SITE PLAN & ARCHITECTURAL COMMISSION AGENDA NOVEMBER 6, 2015

Site Plan and Architectural Commission

Project Joseph Office Park Phase 2
 Joseph Office Park LLC, Applicant; Mark McKechnie, Oregon Architecture,
 Inc., Agent

Project Human Bean Coffee Kiosk Replacement
 Applicant: Tom Casey, Trustee; Agent: Thornton Engineering, Inc.

SITE PLAN SHOWING SOUTHERN DRIVEWAY PRELIMINARY DESIGN & CONFLICT
SUBMITTED BY MIKE THORNTON AT PUBLIC HEARING

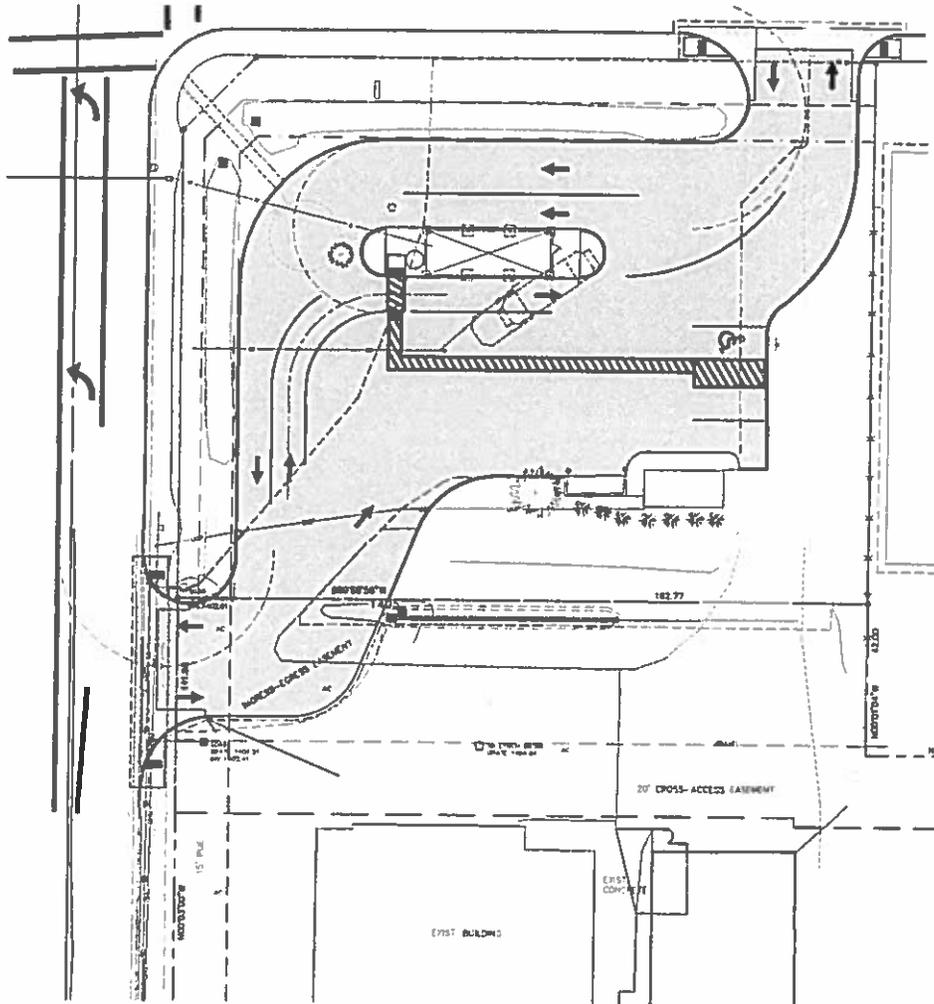
Decision: The Commission modified the language in Item A.3. of the Public Works Staff Report dated October 6, 2015, specifying that the southerly half of the driveway on Holly Street be completed with the redevelopment of the site to the south.

8. The applicant shall comply with the Public Works Department staff report received October 6, 2015. The Commission modified the language in Item A.3., specifying that the southerly half of the driveway be completed with the redevelopment of the site adjacent to the south (Exhibit P).
